Access Compliance Report

Public Rights-of-Way

(Curb Ramps)

| Intersection ID: 45061 | Main Street: EVANGELION_CT | Cross Street: REDDING_GLEN_AV | Location: SW |

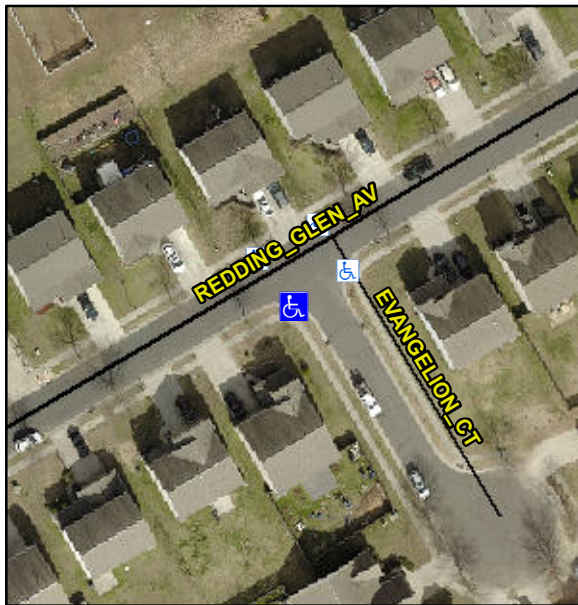
| ADA ID: E1E065FFFDCE | Ramp Type: PerpDiag | Initial Pass/Fail: Fail | Overall Compliance: No |

Not Found, R304.5.1

| Compliance | Description | Data | Compliance | Description | Data |
|------------|-----------------------|------|------------|-----------------------------|------|
| No | Ramp Width (in) | 47.0 | Yes | Ramp XSlope (%) | 0.7 |

Remove & Replace Curb Ramp With Two New Directional Ramps or Equivalent.
